Access Compliance Report

Public Rights-of-Way

(Curb Ramps)

Intersection ID: 44786	Main Street: AYRSLEY_TOWN_BV	Cross Street: KINGS_PARADE_BV	Location: SE
ADA ID: D5D5B8A52F4C	Ramp Type: Perp	Initial Pass/Fail: Fail	Overall Compliance: No
		Severity Score: 12.5

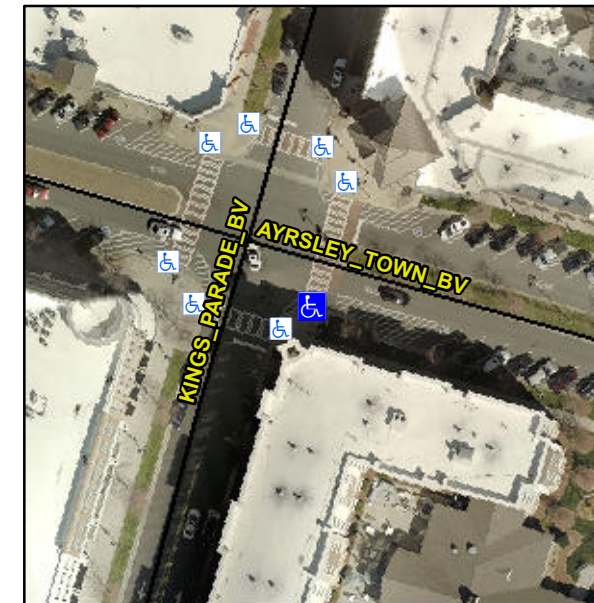
Not Found, R304.2.2

Compliance	Description	Data	Compliance	Description	Data
N/A	Ramp Length (in)	86.0	No	Ramp Slope (%)	9.4
Yes	Ramp Width (in)	48.0	Yes	Ramp XSlope (%)	1.5
N/A	Flare Type LT	N/A	N/A	Flare Type RT	N/A
N/A	Flare Slope LT (%)	N/A	N/A	Flare Slope RT (%)	N/A
N/A	Flare Traversable LT?	N/A	N/A	Flare Traversable RT?	N/A
N/A	Landing Length (in)	N/A	N/A	DWS Provided?	N/A
N/A	Landing Width (in)	N/A	N/A	DWS Contrast?	N/A
N/A	Landing Slope (%)	N/A	N/A	DWS Length (in)	N/A
N/A	Landing X Slope (%)	N/A	N/A	DWS Full Width?	N/A
N/A	Landing Curb? (Y/N)	N/A	N/A	DWS Offset (in)	N/A
N/A	Shared Landing?	N/A			
N/A	Gutter Ponding?	N/A	N/A	Gutter Slope (%)	N/A
N/A	Gutter Lip Ht (in)	N/A	N/A	Gutter X Slope (%)	N/A
N/A	Painted X Walk1?	Yes	N/A	Painted X Walk2?	N/A
	X Walk 1 Direction	To NE		X Walk 2 Direction	N/A
N/A	X Walk 1 Width (in)	110.0	N/A	X Walk 2 Width (in)	N/A
	X Walk 1 Slope (%)	2.5		X Walk 2 Slope (%)	N/A
	X Walk 1 X Slope (%)	2.8		X Walk 2 X Slope (%)	N/A

**Remove & Replace Entire Ramp.
Restripe Crosswalk.**
